COLORADO
Division of Reclamation,
Mining and Safety
Department of Natural Resources

RE: East Rigden Pit, Permit No. M-1979-097, Acreage Reduction Request No. 1 (AR-01), Adequacy Review No. 1

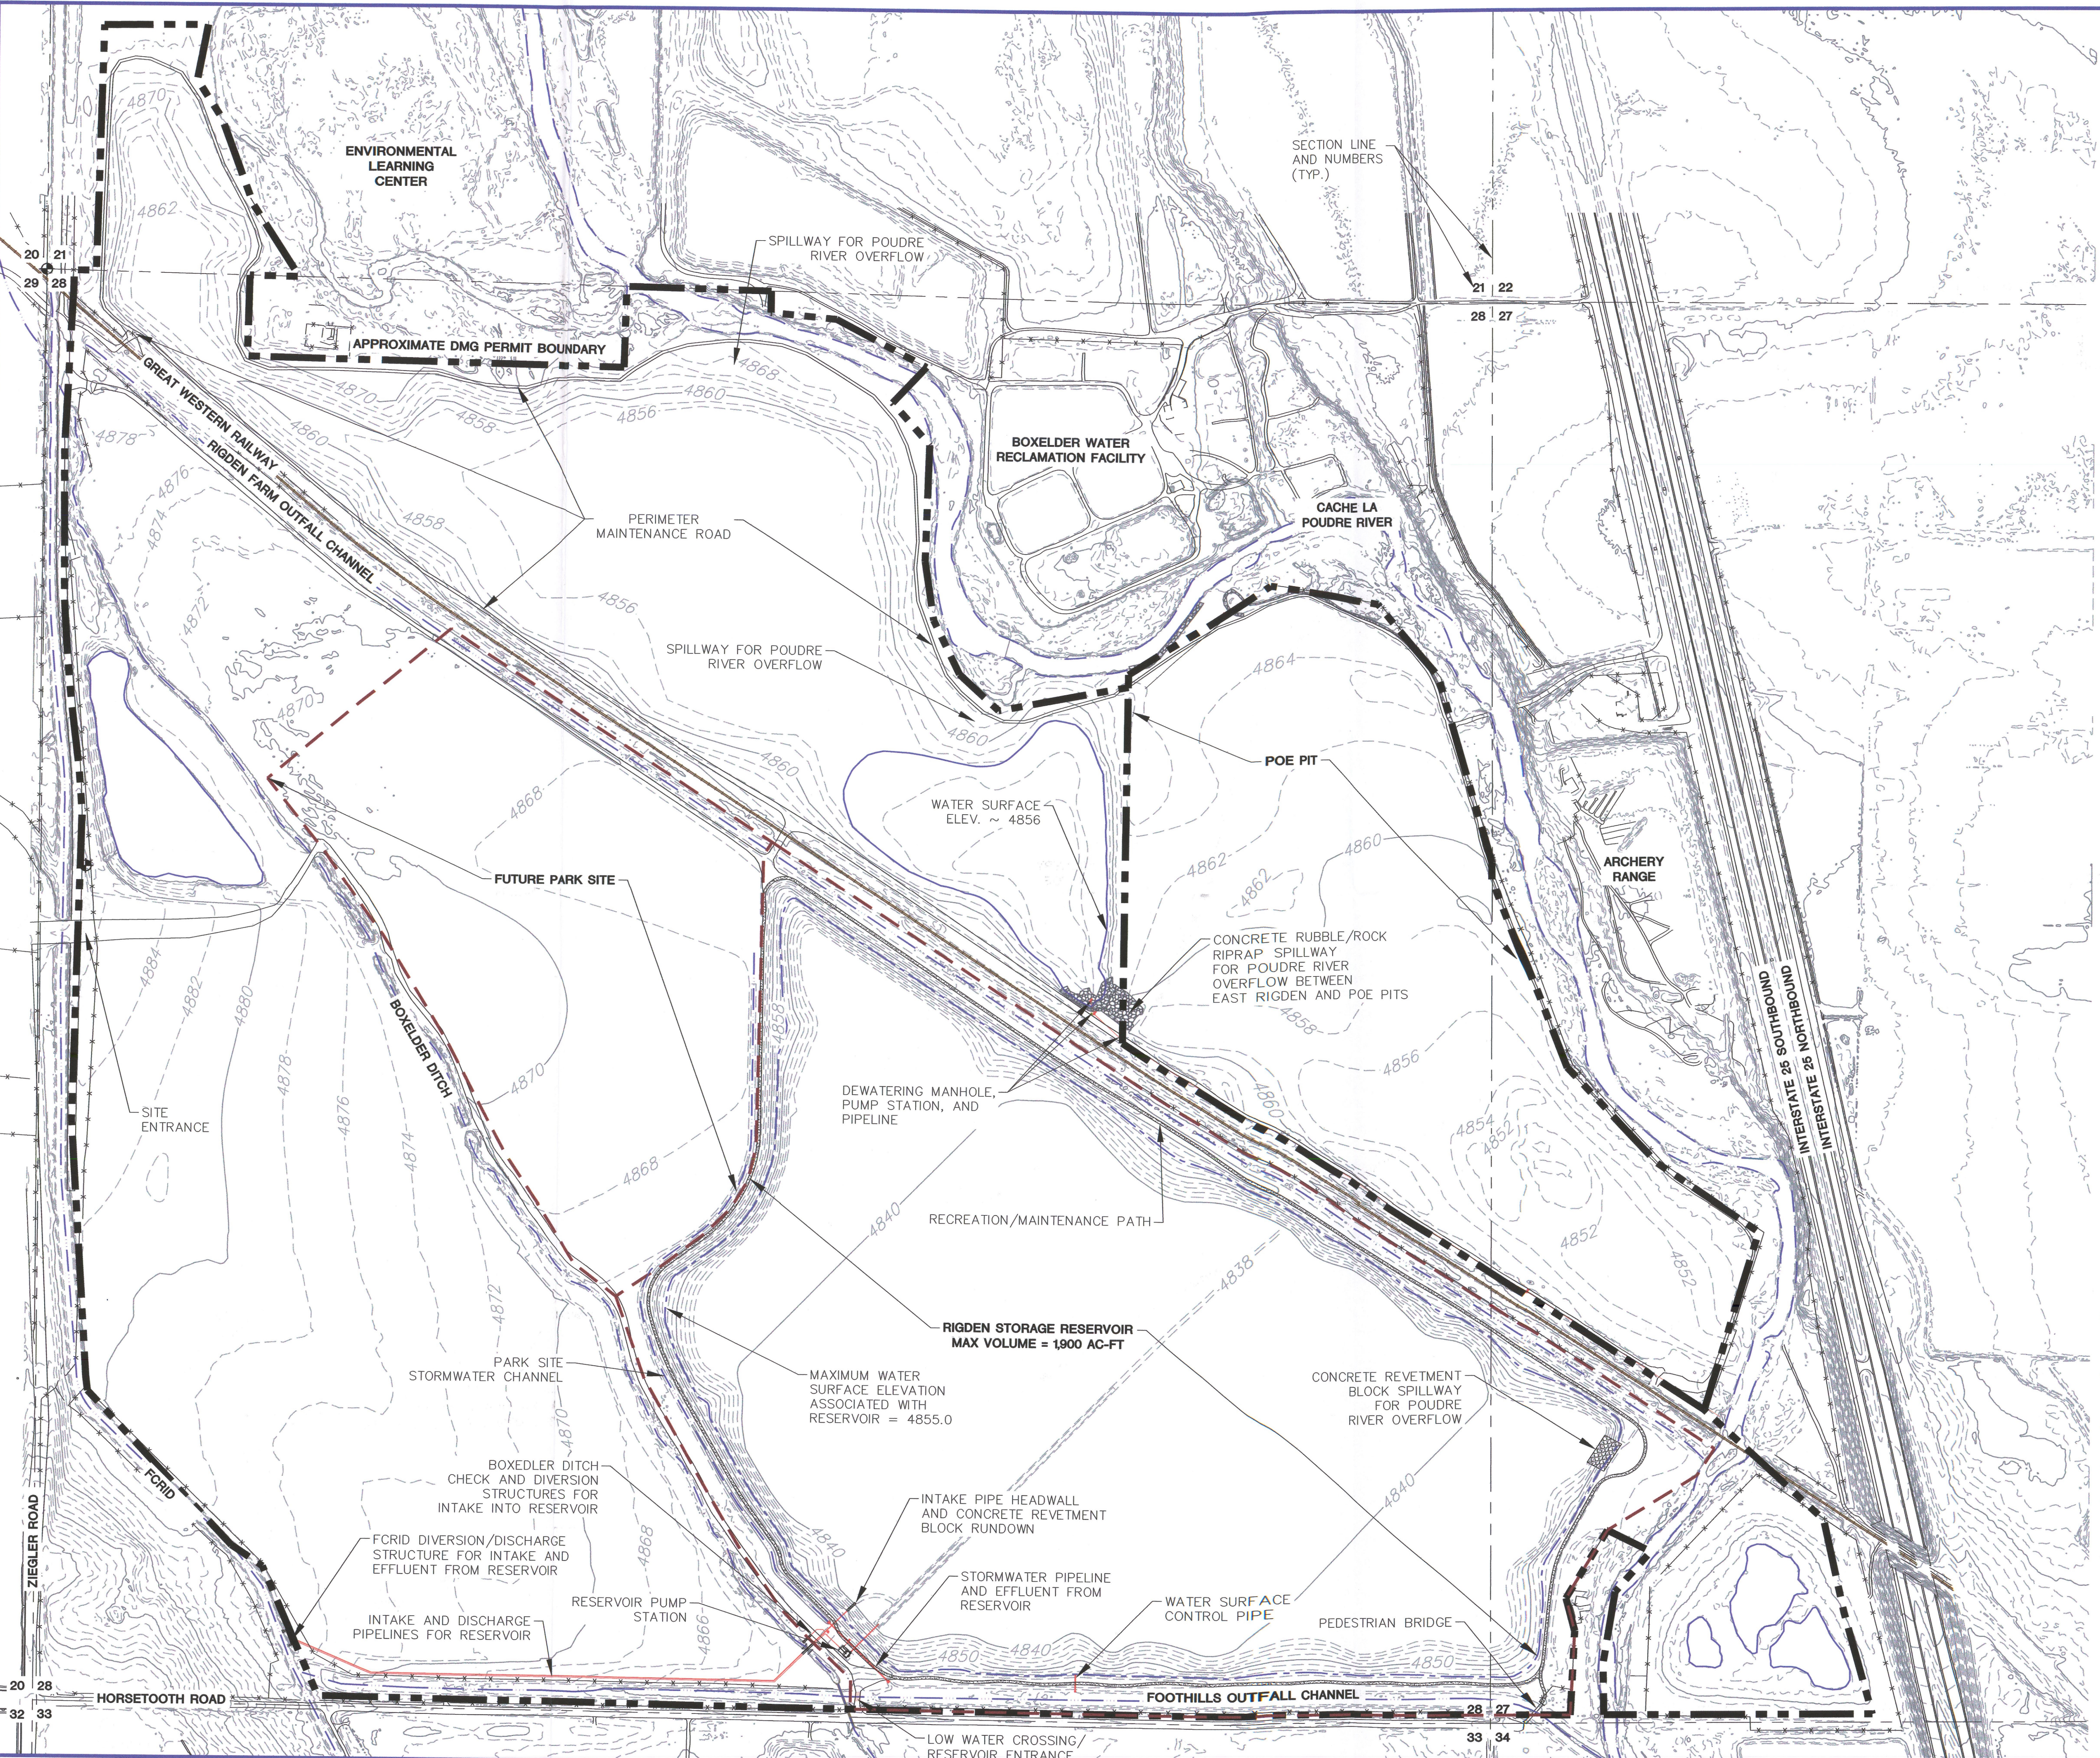
- 1) Your submittal requests a partial release of 16 acres from the southeastern portion of the permit area located east of the Cache La Poudre River. However, based on approved permit maps (see enclosed Property Map and Reclamation Plan Map), the Division estimates the southeastern portion of the permit area located east of the river to be comprised of approximately 17.5 acres (see enclosed Google Earth images of site with Division's estimated acreage). If the intent is to remove the entire portion of the permit area located east of the river, please submit a revised proposal with the correct acreage amount.
- 2) Please submit an updated mining plan map (if mining activities are expected to continue) and reclamation plan map for the site, which accurately depict the new permit boundary if the acreage reduction is approved.
